Groundwater Management Plan

Santa Clara River Valley Groundwater Basin, East Subbasin

December, 2003

- I. Groundwater and Surface Water Monitoring Protocols
- II. Comments and Responses (separately bound)

Figure 5-1
Water Level Monitoring Well Network
Santa Clara River Valley East Groundwater Subbasin

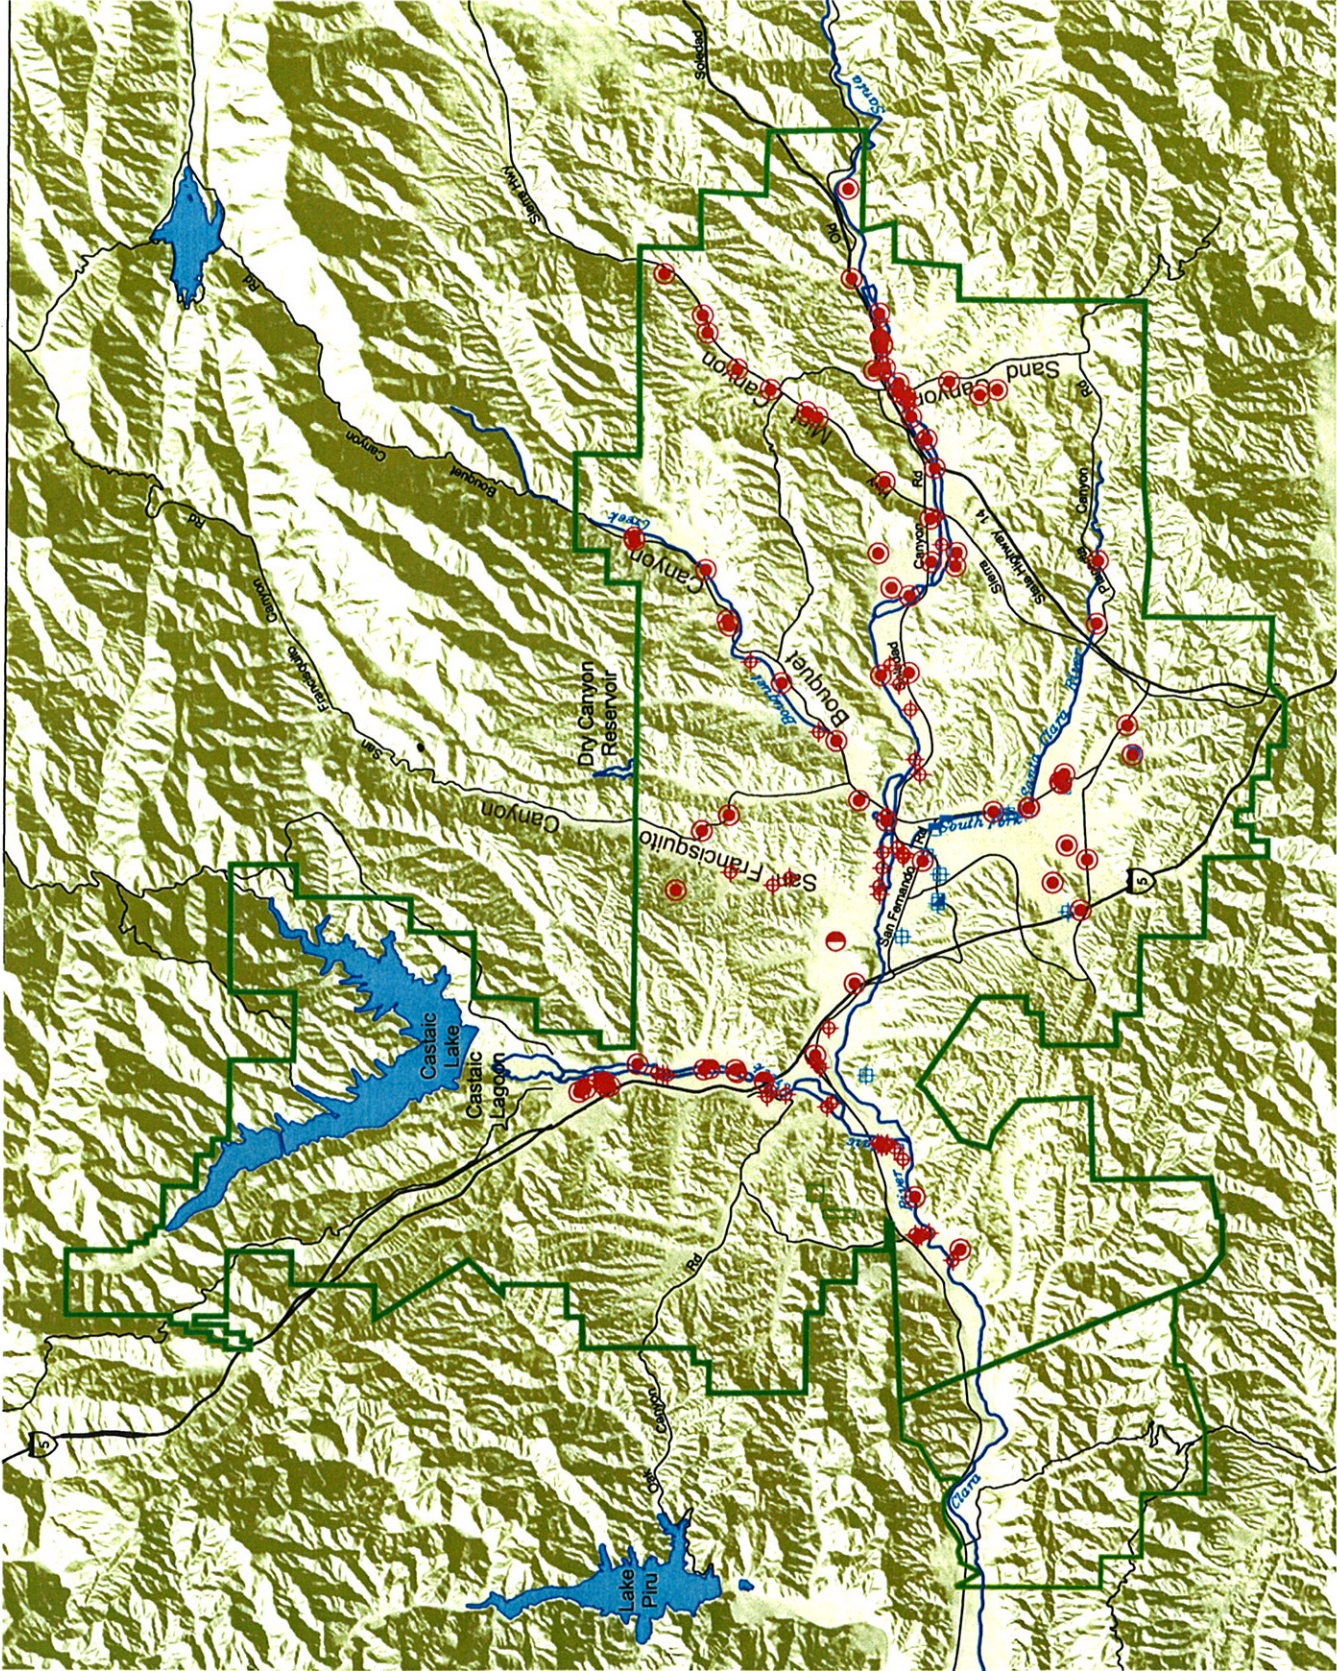
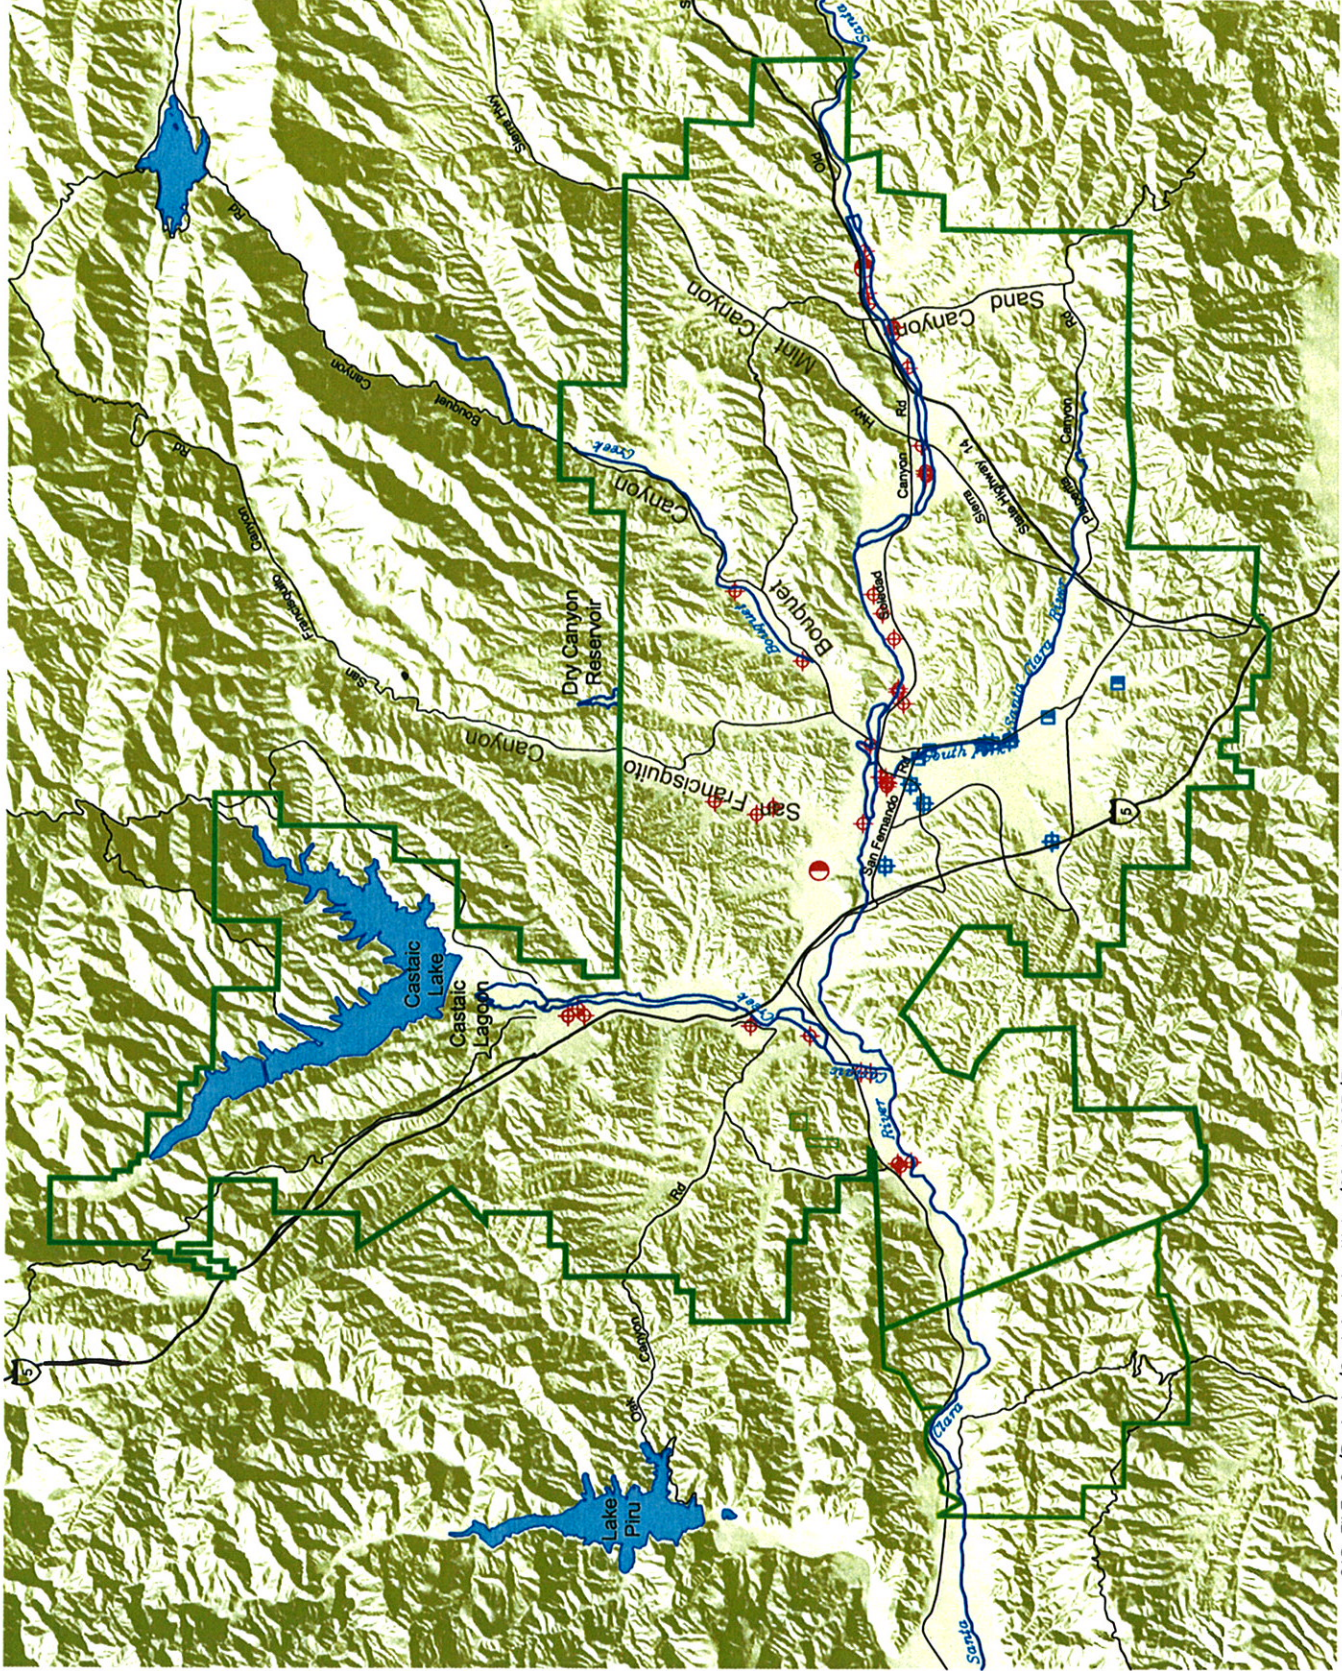
First, I commented previously on the proposed network of monitoring wells and the public availability of data. The monitoring wells in figures 5-1 and 5-2 appear to cover a wide range of the valley. However, the text on p. 27 states the network will be "mostly as illustrated in figures 5-1 and 5-2, but possibly expanded..." I hope the final network is extensive and covers all areas of the valley. Further expansion of the network would add valuable data points and should be encouraged.

Figure 5-3

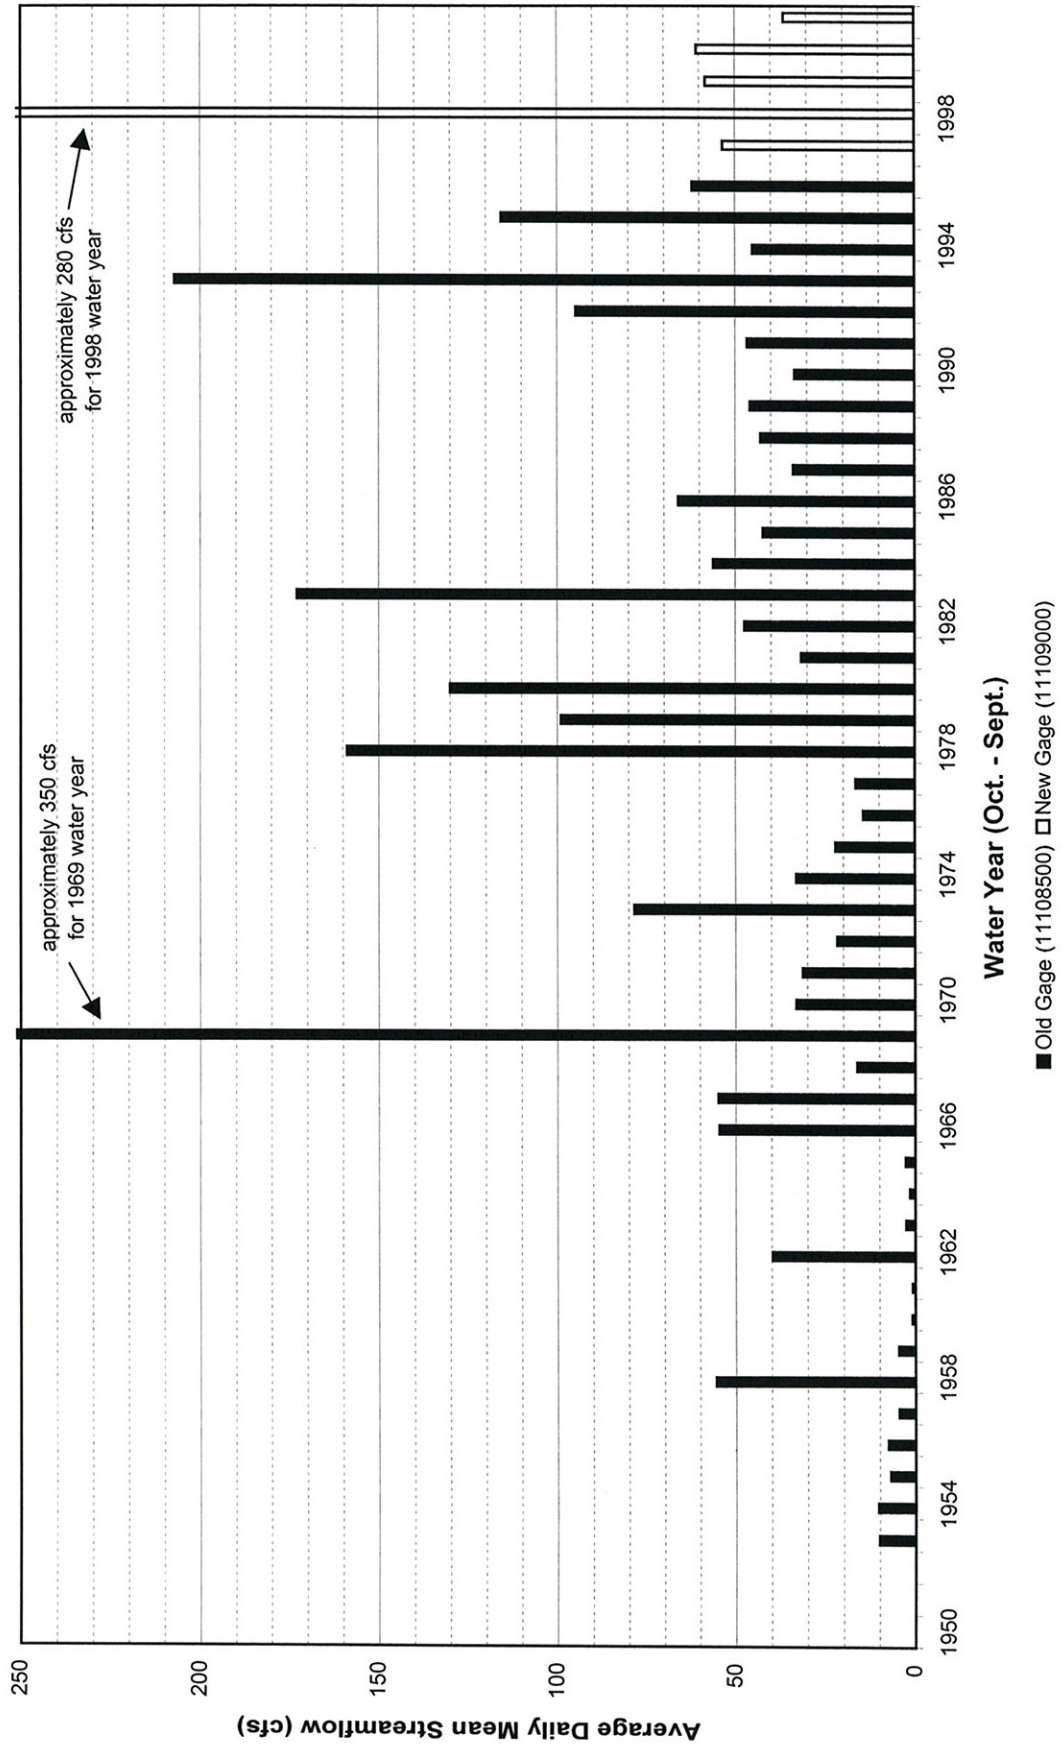
Figure 5-3. The average daily mean streamflow data appears to be shifted one year on the histogram graph. As an example to show the error, the histograms suggest that there were high flow years in 1968 and 1997. The high flow years were actually 1969 and 1998;

Figure 5-4

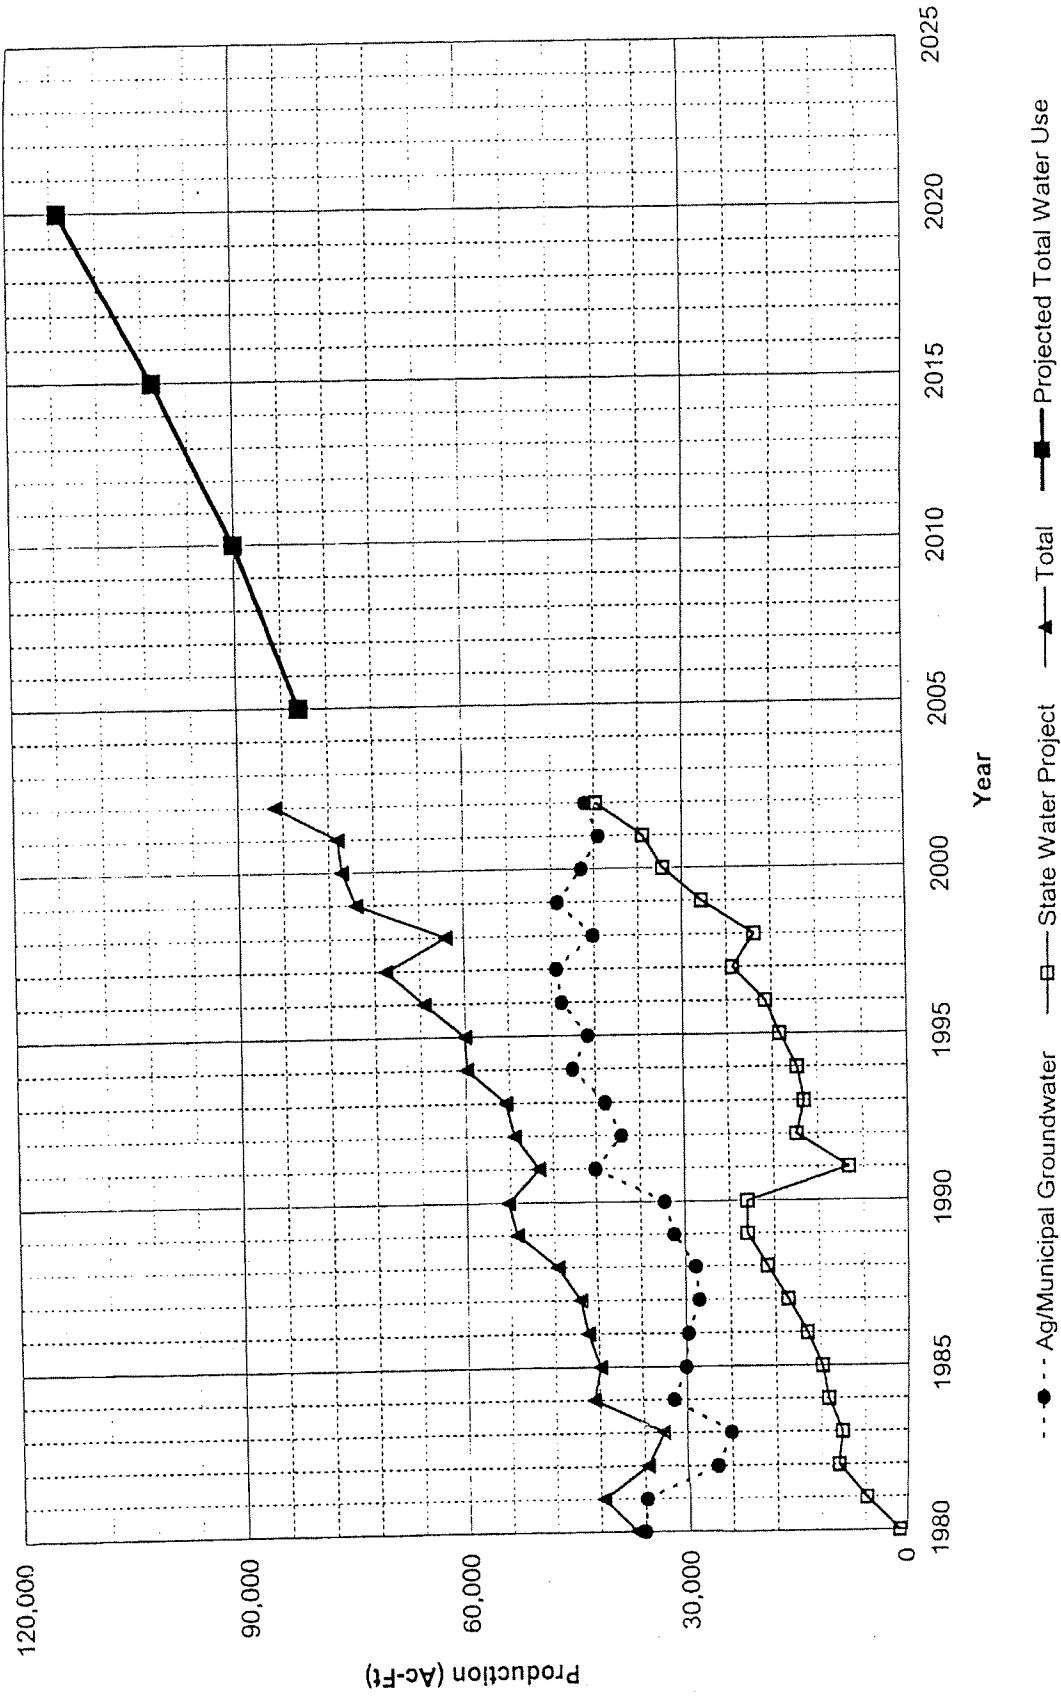
The SWP water received in 1991 is erroneous. The chart indicates 8,000 a/f. It is incorrect. CLWA only received 10% of its then allocation 54, 200 a/f. The 10% was received in January and the plant shut down in March. See Exhibit A. It should be noted that this is a state water project interruption for months, not a reduction.
